Amend the claims as shown on the attached: First Amendment: Claims Marked Up.
Amend Figure 3 of the drawings as shown on the attached: Amended Drawing, page 3/6.

ANNOTATED MARKED UP DRAWING
 PROPOSED AMENDMENT

REFUSE CONTAINER LID

FIG. 3

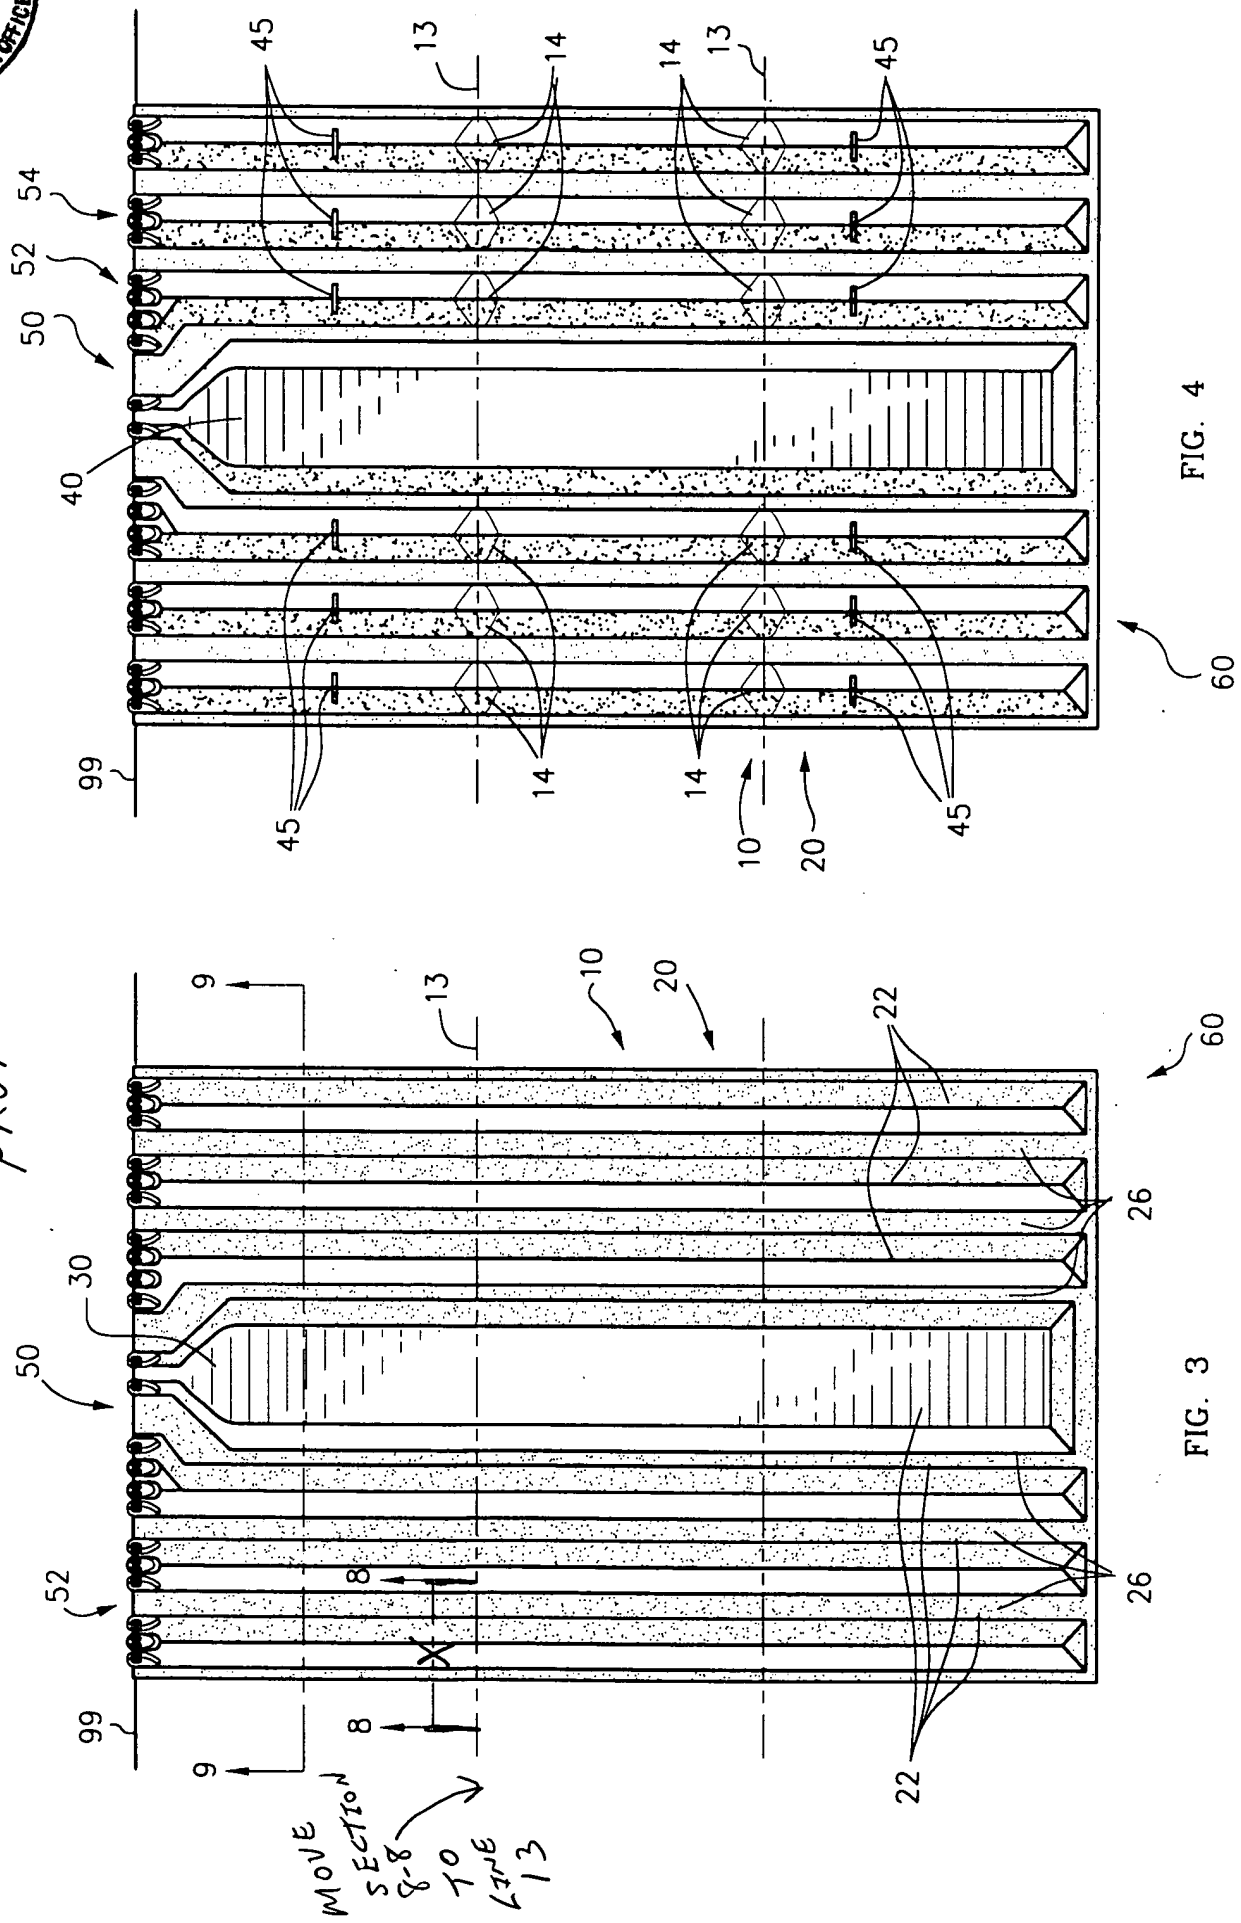
Figure 3 of the drawing has been amended to move section 8-8 to the bend zone 13 as supported in the Specification discussion of Figures 4 and 10.
